OURISMAN FORD AT MONTGOMERY MALL SITE PLAN AMENDMENT NO. 82009014C

Request to 1) remove proposed sound barrier fence; 2) make minor adjustments to passive recreation area layout and planting design; 3) reconfigure private courtyard areas; 4) reconfigure walk-up unit entries, 5) remove one walk-up unit; 6) make minor revisions to architectural elevations; 7) eliminate four stormwater facilities; and 8) revise the stormwater facility footprint at the southeast corner of the building.

No. 82009014C

MCPB

Figure 3 - Proposed Redline Changes Site Plan No. 82009014C

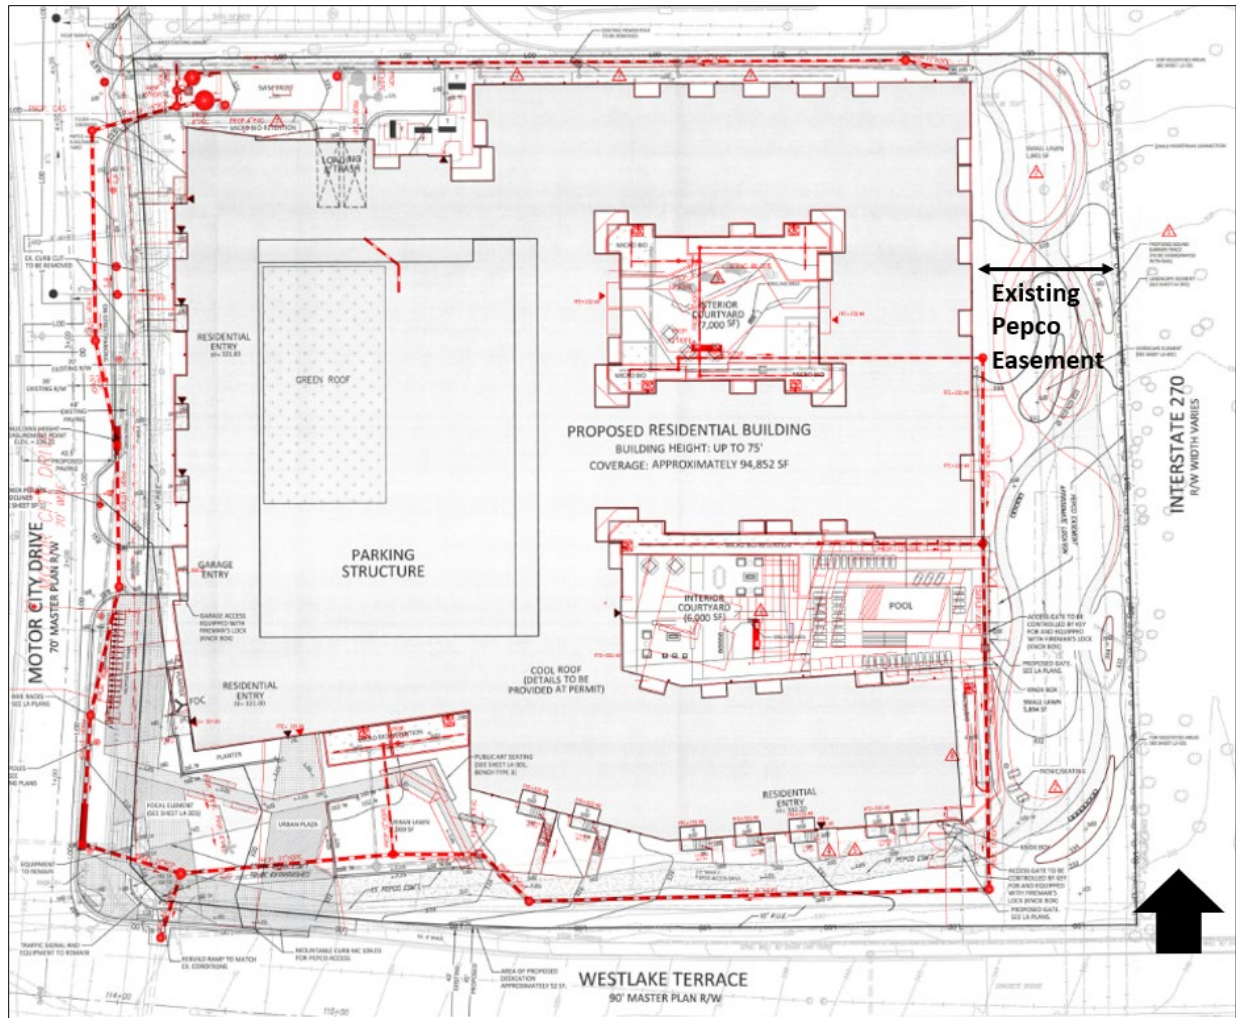
The Amendment seeks to remove the eight-foot noise barrier fence previously proposed along the eastern boundary of the Site between the building and I-270. The sound barrier was originally intended to mitigate noise in the Project's common outdoor areas. The Applicant team coordinated extensively with Pepco and the Maryland Department of Transportation State Highway Administration (MDOT SHA) following approval of the previous Site Plan application, however neither agency would allow installation of the sound fence within either the adjacent MDOT SHA right-of-way or the Pepco easement onsite. Pepco determined that there were insufficient vertical and horizontal clearances necessary to avoid conflicts between the proposed sound barrier fence's footers and the existing underground utility infrastructure (Attachment D). The MDOT SHA denied permission to install the fence within the adjacent MDOT SHA right-of-way because it would encroach on improvements included with the State's proposed traffic relief public private partnership (P3) project along I-270 (Attachment C).

The Applicant seeks approval of minor modifications to the shape, configuration, and planting design of the two building courtyards and the passive recreation area located to the east of the building. The number and quality of the features within each amenity area will be retained.

The Amendment includes the removal of one walk-up unit on the southeastern corner of the building. As previously approved, this unit would have an outside entrance directly into the bedroom instead of the living room, and the unit's patio would have been back-to-back with the adjacent unit. Some of the building's other proposed walk-up units have slightly reconfigured entryways with additional steps or minor reorientations.

In addition, the Amendment proposes minor architectural changes including adjustments to windows and balcony doors, while maintaining the overall design intent and quality of the building façade.

Changes to the Project's stormwater management facilities were required by MCDPS during the permit review process. The changes approved by MCDPS have been incorporated into this Amendment.
